BURLINGTON DEVELOPMENT REVIEW BOARD Tuesday April 4, 2017, 5:00 PM Conference Room 12 PUBLIC HEARING NOTICE

BURLINGTON DEVELOPMENT REVIEW BOARD Tuesday, April 4, 2017, 5:00 PM Conference Room 12, City Hall, 149 Church St, Burlington, VT AGENDA

To: Development Review Board
From: Mary O'Neil, AICP, Principal Planner
Date: April 4, 2017
RE: ZP17-0791CA; 323-325 College Street

Overall Site Plan

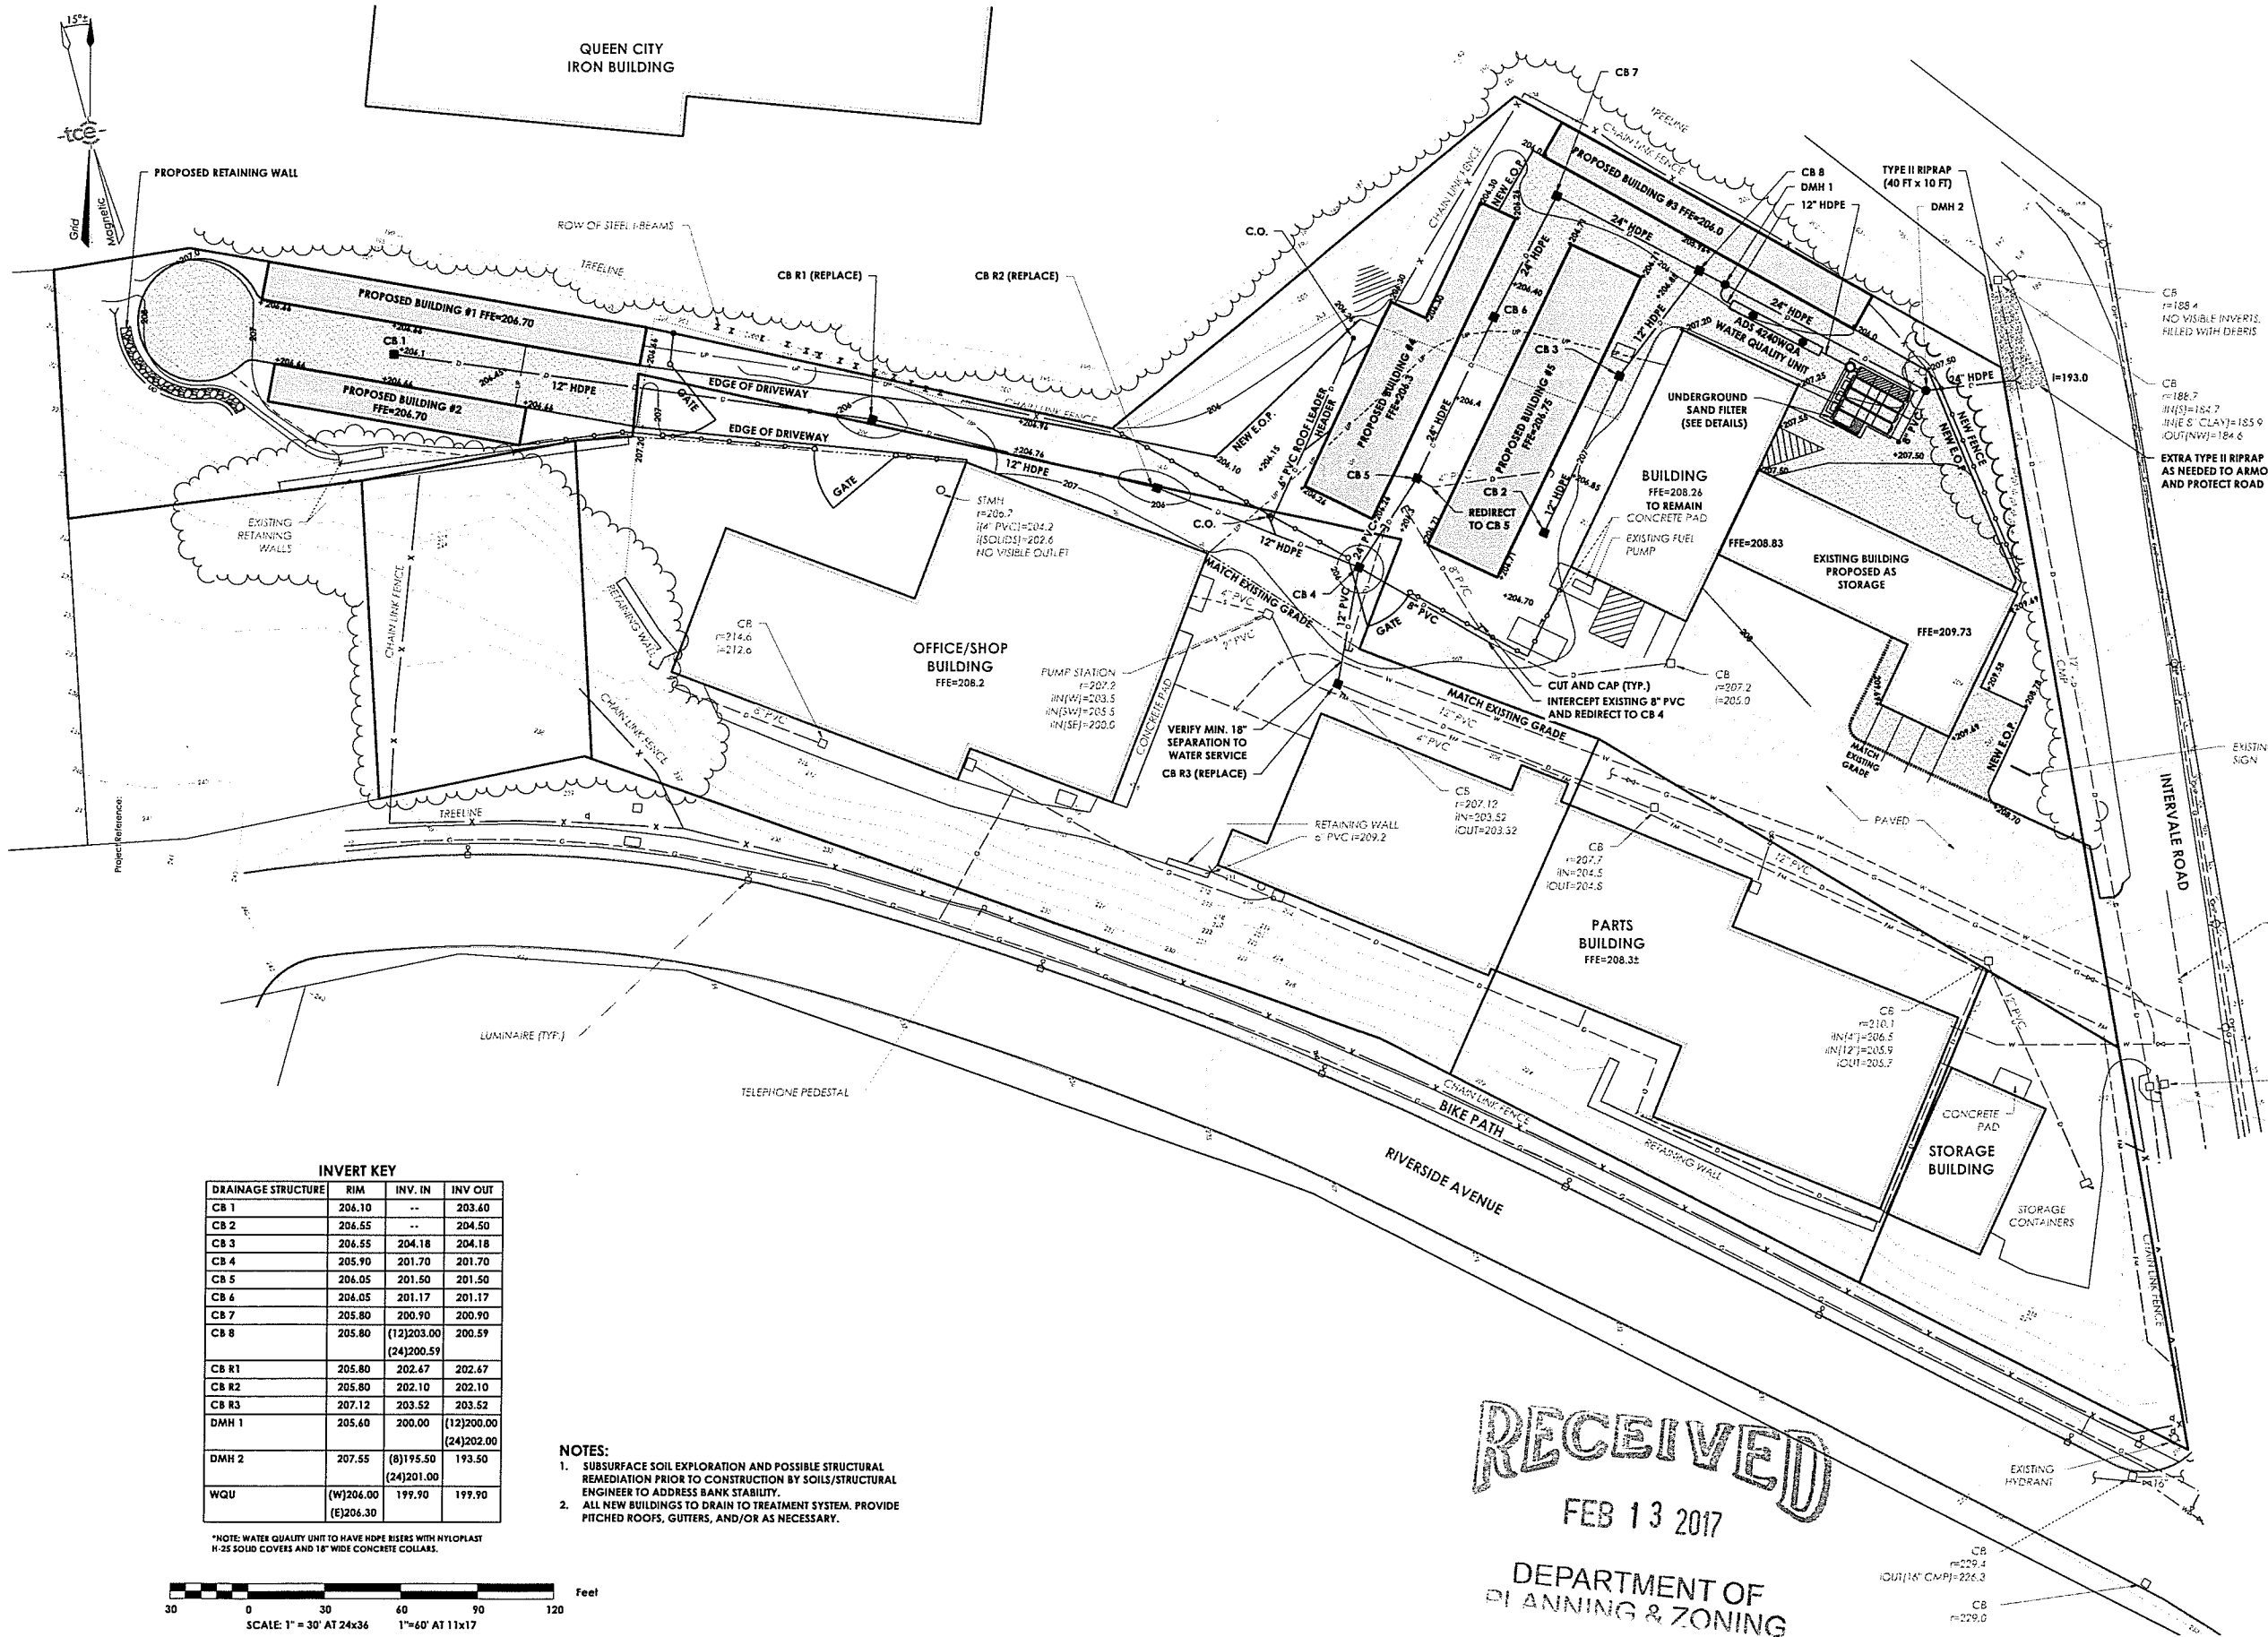
The conversion of 5,076 sf. of warehouse to self storage will not incur Impact Fees per this standard. The remaining new square footage (12,900 per Table Plan C2-01) will be assessed for Impact fees. Per that calculation, the following estimated fees will be due:

The complex has an existing pattern of circulation throughout the buildings. The proposed self storage buildings will profit from that access and infrastructure. Per Table 8.1.8-1, 7 new parking spaces are provided. See Plan C2-01. **Affirmative finding.**

Grading & Drainage Plan

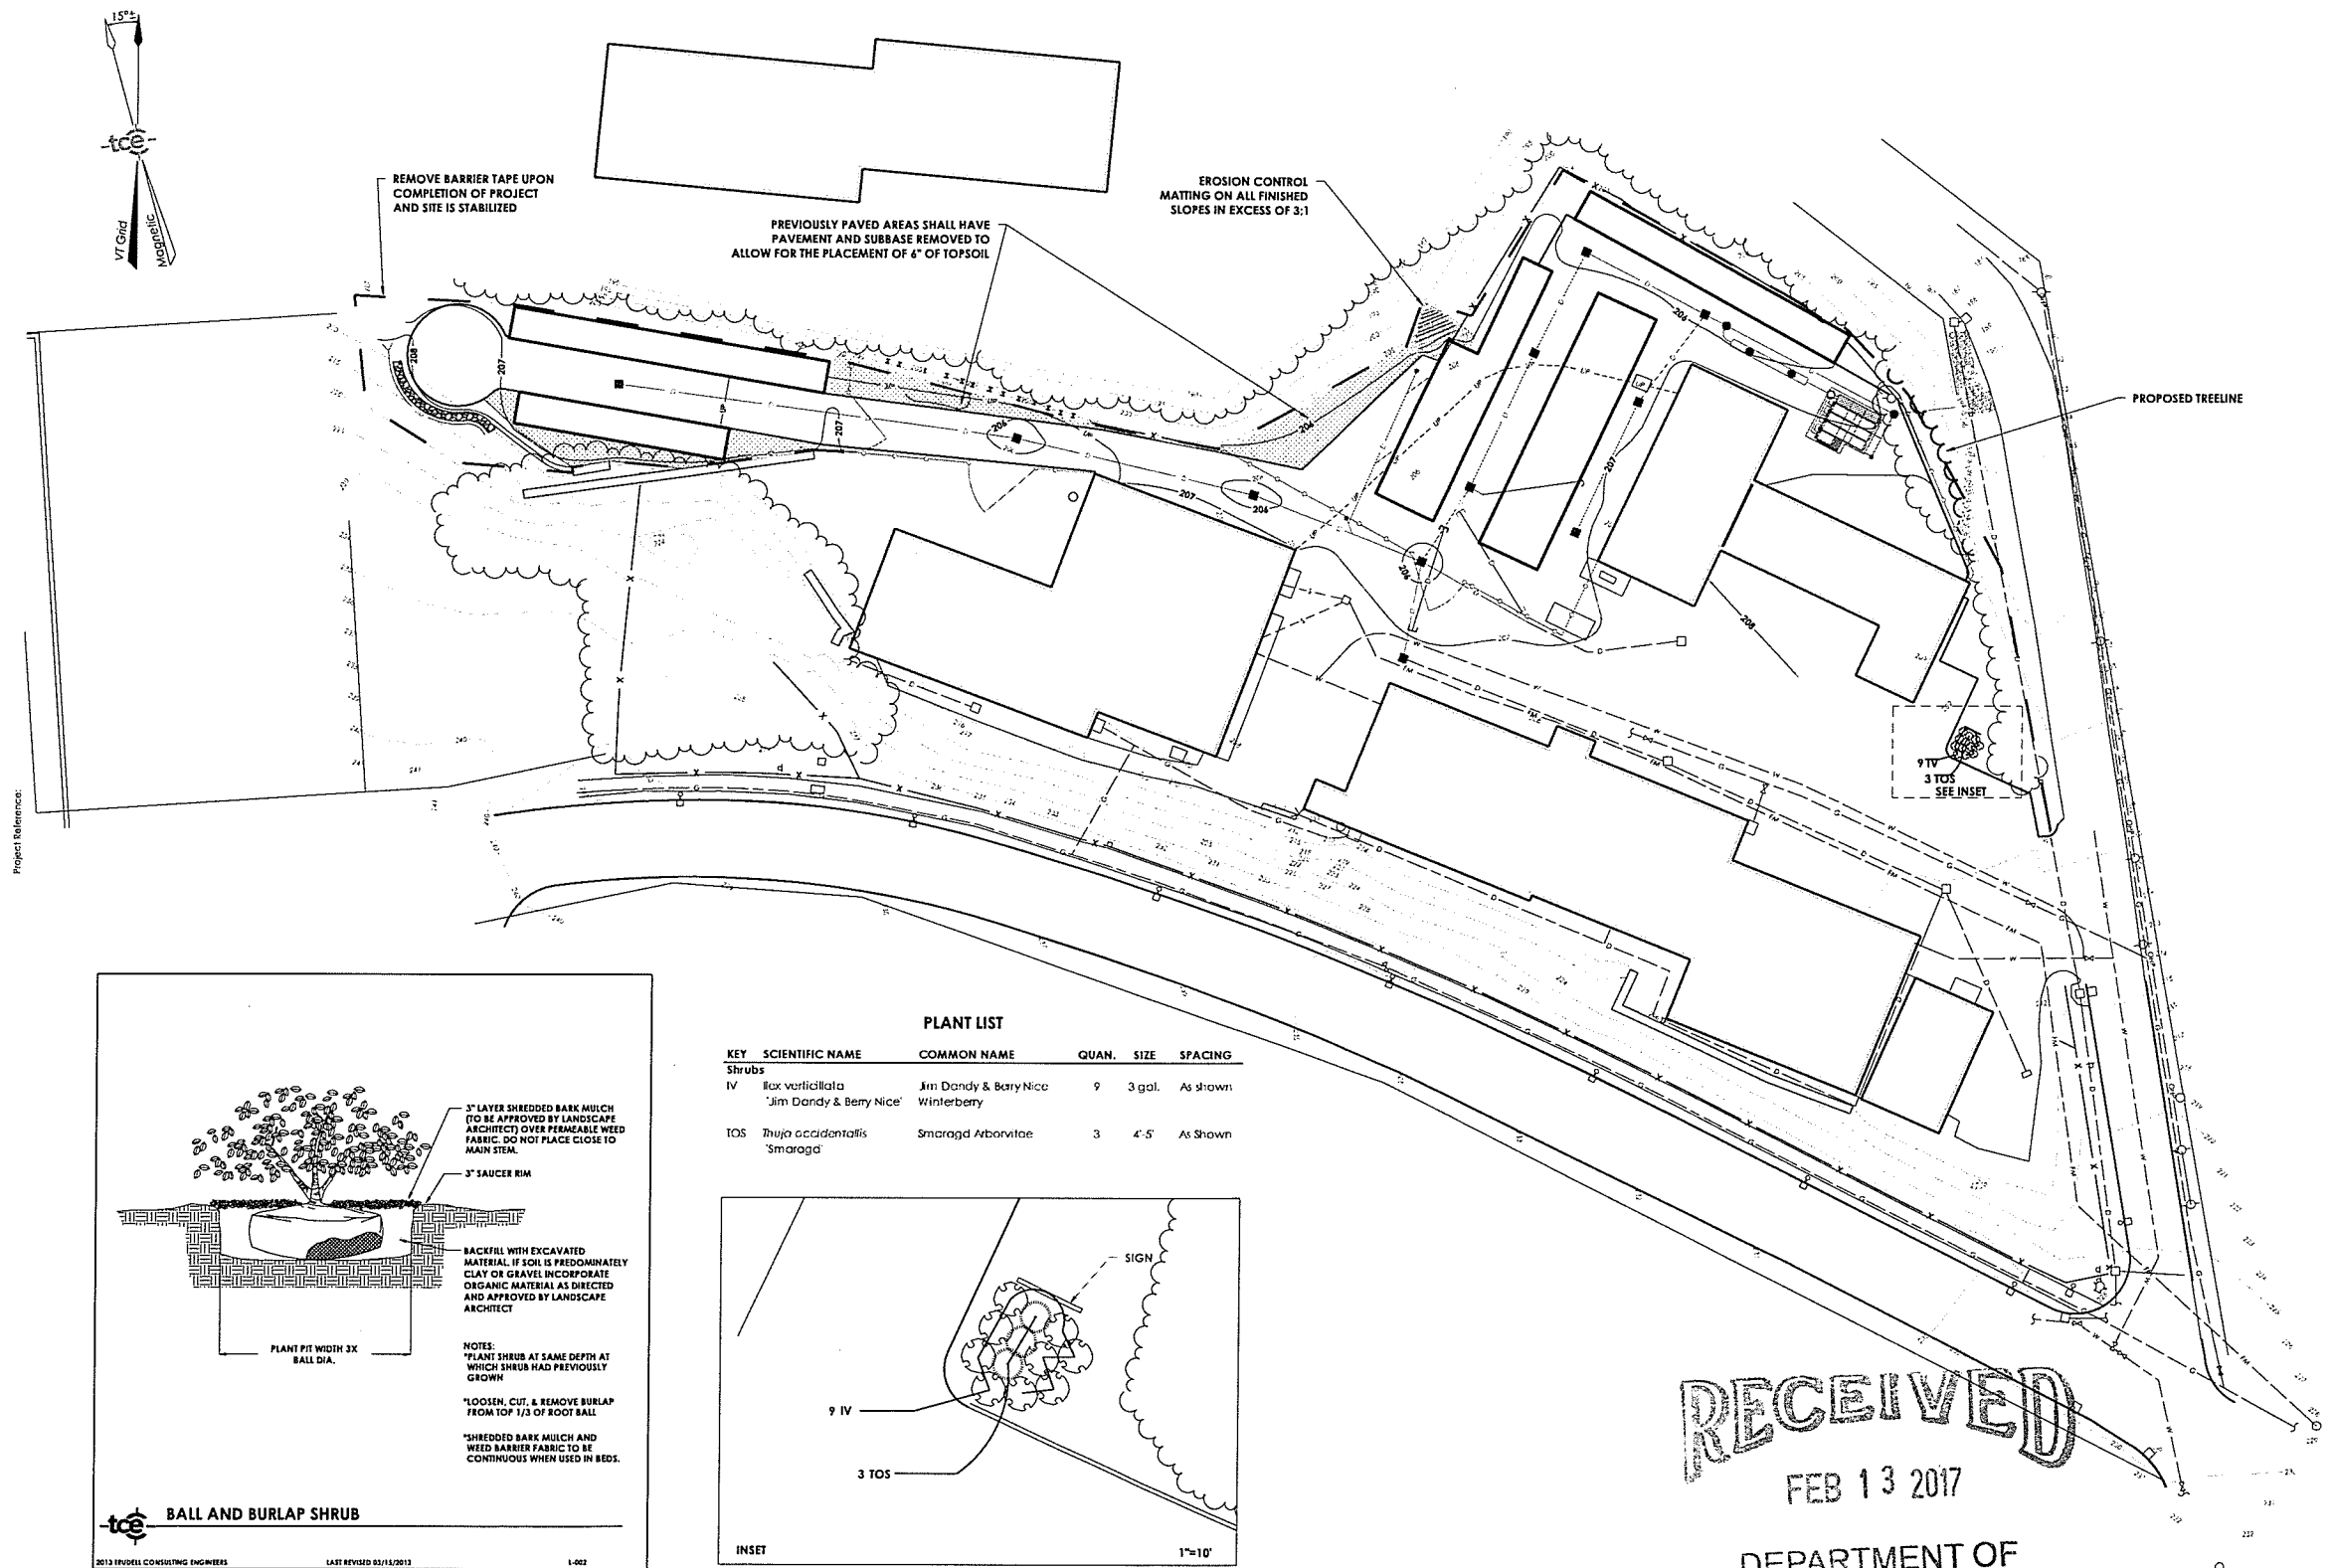
The installation of the drainage/stormwater utility will require some soil exploration prior to construction to assure site stability. The grading and drainage plan is subject to DPW/Stormwater program review and approval. **Affirmative finding as conditioned.**

3. The grading and drainage plan is subject to DPW/Stormwater program review and approval **prior to release of the permit.**
4. The Erosion Prevention and Sediment Control Plan will require written approval by the Stormwater Division **prior to release of the permit.**

Proposed parking configuration

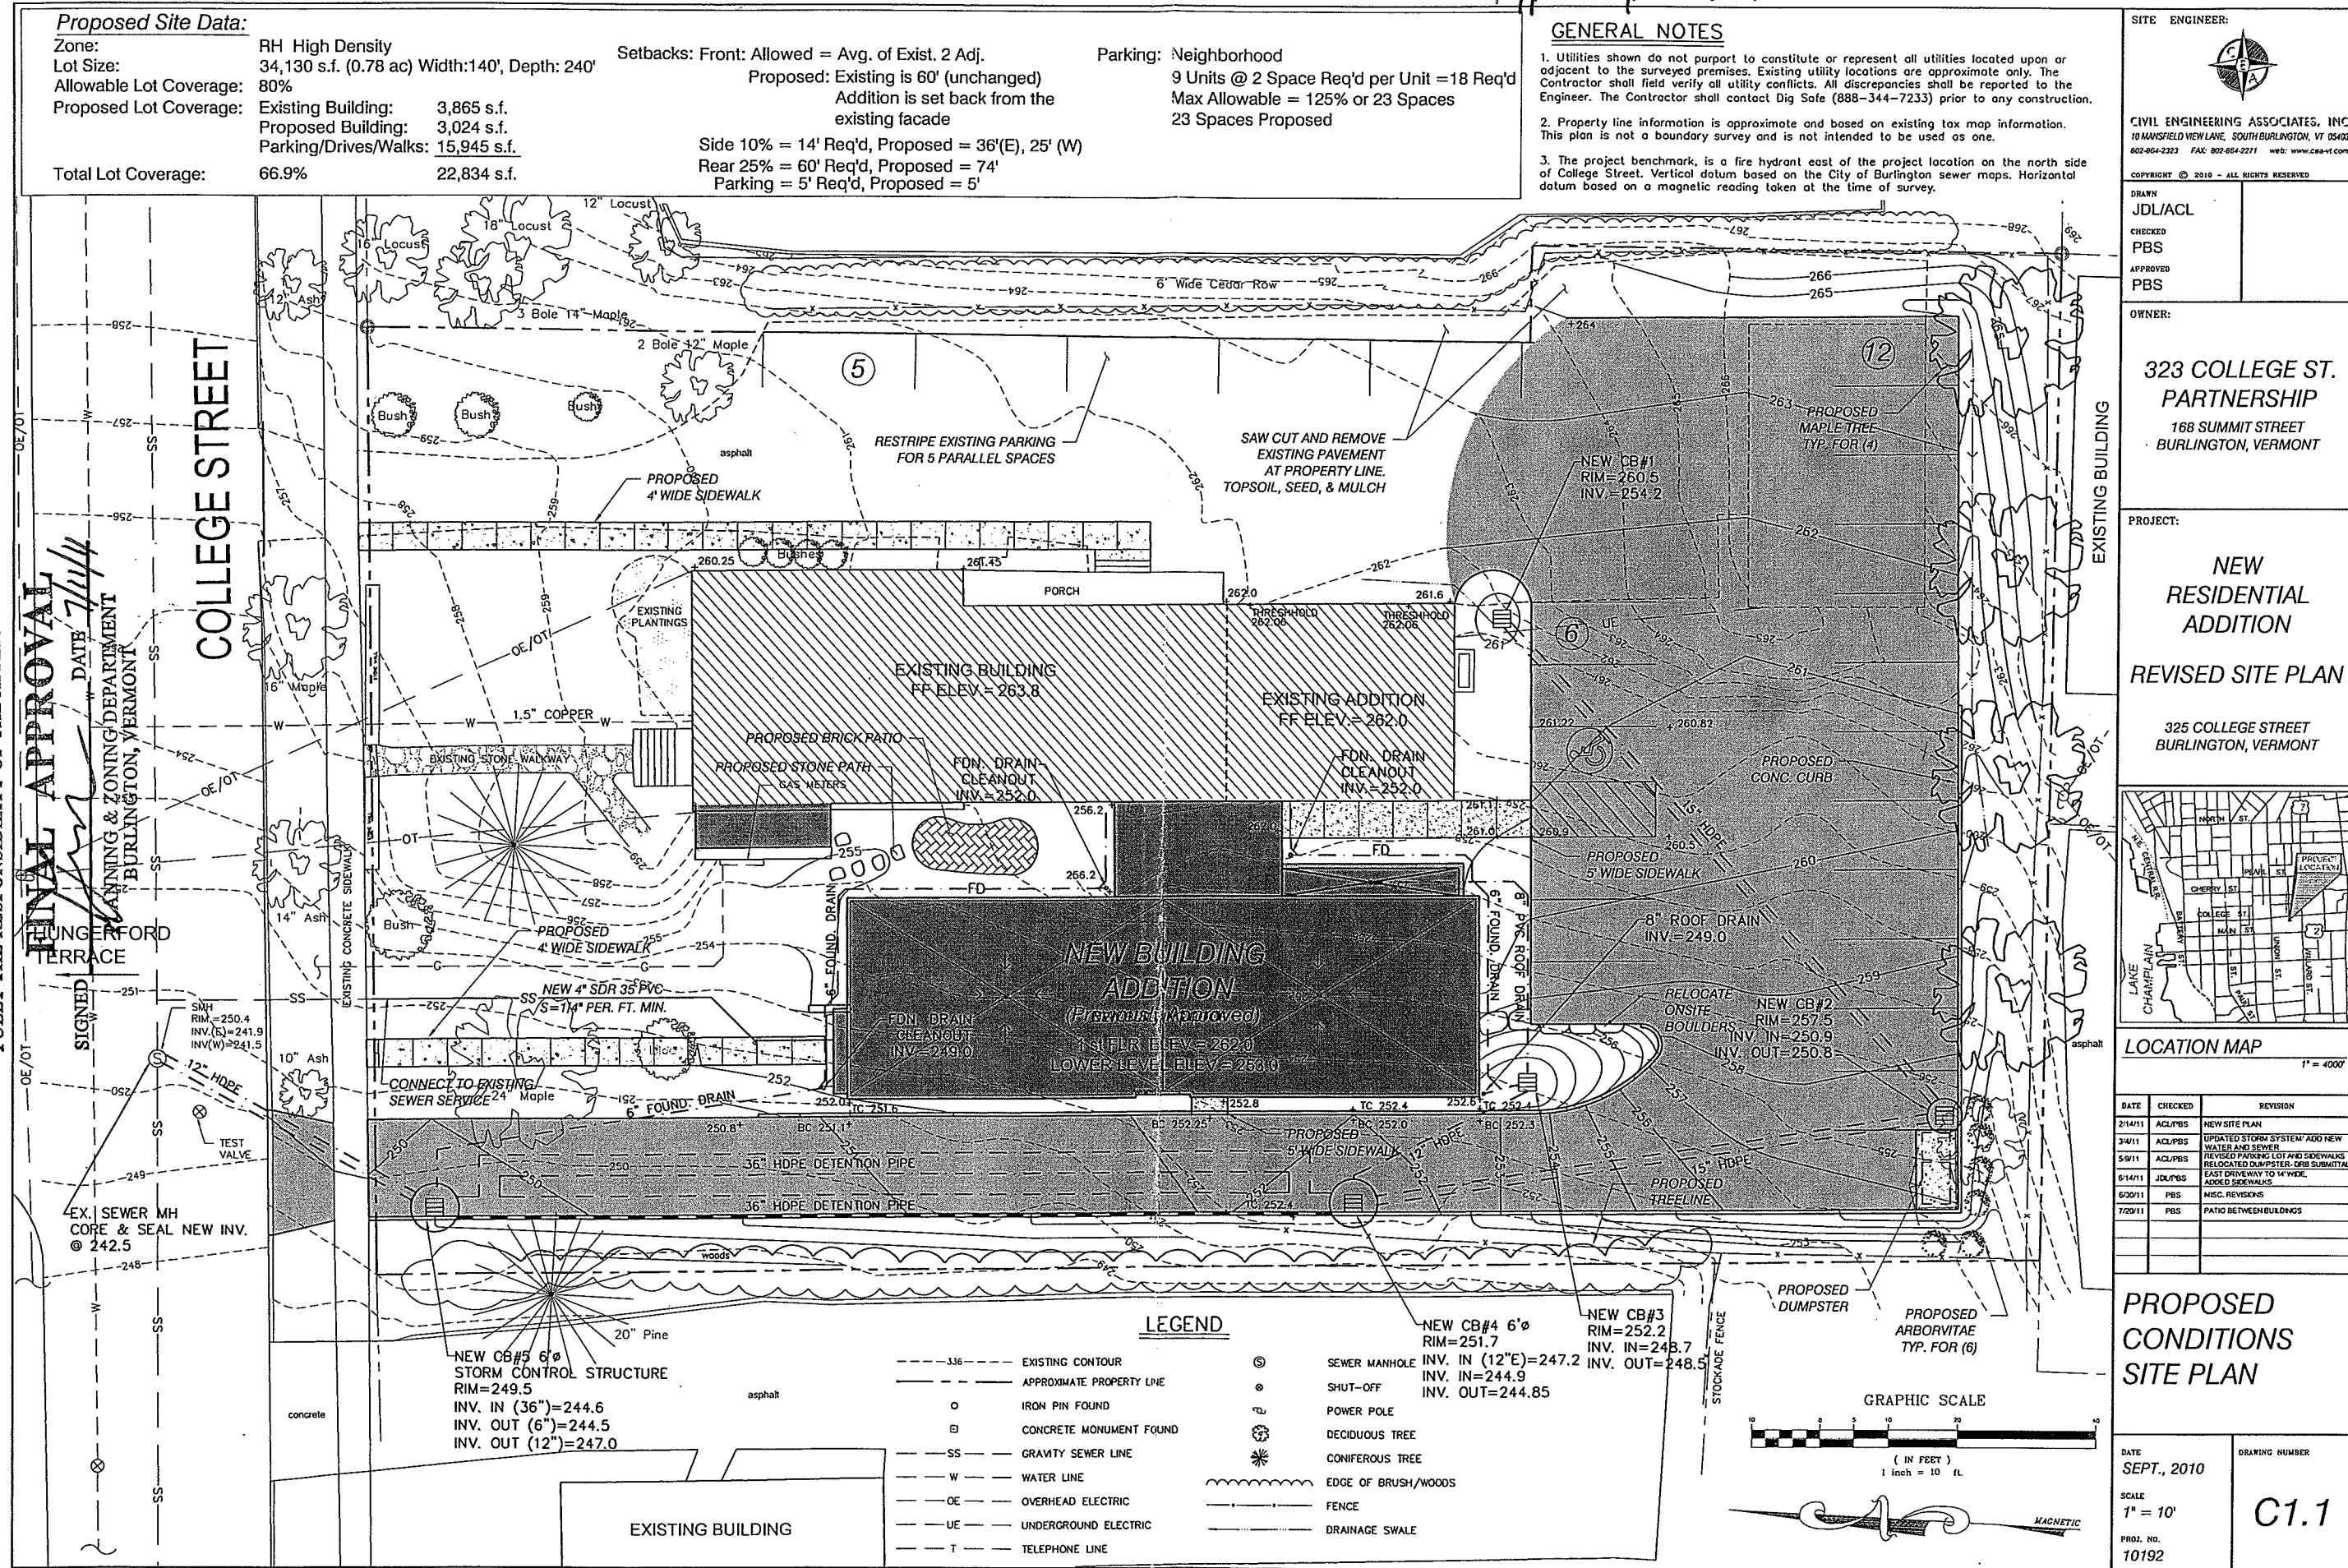
(The submitted site plan defines 30 spaces; however, the striped space in the rear is the identified pedestrian path to the entrance approved under the previous permit ZP11-0086CA/MA. It also acts as a loading area for the adjacent handicapped parking space.)
